Access Compliance Report

Public Rights-of-Way

(Curb Ramps)

Intersection ID: 49144	Main Street: AMBER_LEIGH_WAY_DR	Cross Street: LOOKOUT_POINT_DR	Location: E
ADA ID: C73C0822180F	Ramp Type: Perp	Initial Pass/Fail: Fail	Overall Compliance: No
Severity Score: 22.5			
Codes/Mitigation Info/Possible Solution		Field Measurements/Component Compliance

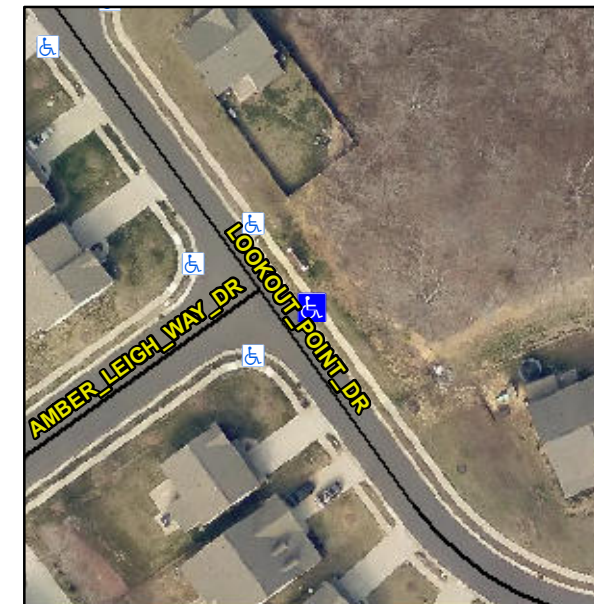
Not Found, R304.5.1, R304.2.2, R304.5.3

Compliance	Description	Data	Compliance	Description	Data
N/A	Ramp Length (in)	47.5	No	Ramp Slope (%)	8.8
No	Ramp Width (in)	47.0	No	Ramp XSlope (%)	2.8
N/A	Flare Type LT	N/A	N/A	Flare Type RT	N/A
N/A	Flare Slope LT (%)	N/A	N/A	Flare Slope RT (%)	N/A
N/A	Flare Traversable LT?	N/A	N/A	Flare Traversable RT?	N/A
N/A	Landing Length (in)	N/A	N/A	DWS Provided?	N/A
N/A	Landing Width (in)	N/A	N/A	DWS Contrast?	N/A
N/A	Landing Slope (%)	N/A	N/A	DWS Length (in)	N/A
N/A	Landing X Slope (%)	N/A	N/A	DWS Full Width?	N/A
N/A	Landing Curb? (Y/N)	N/A	N/A	DWS Offset (in)	N/A
N/A	Shared Landing?	N/A			
N/A	Gutter Ponding?	N/A	N/A	Gutter Slope (%)	N/A
N/A	Gutter Lip Ht (in)	N/A	N/A	Gutter X Slope (%)	N/A
N/A	Painted X Walk1?	No	N/A	Painted X Walk2?	N/A
	X Walk 1 Direction	To SW		X Walk 2 Direction	N/A
N/A	X Walk 1 Width (in)	N/A	N/A	X Walk 2 Width (in)	N/A
	X Walk 1 Slope (%)	2.5		X Walk 2 Slope (%)	N/A
	X Walk 1 X Slope (%)	1.7		X Walk 2 X Slope (%)	N/A

Remove & Replace Entire Ramp.
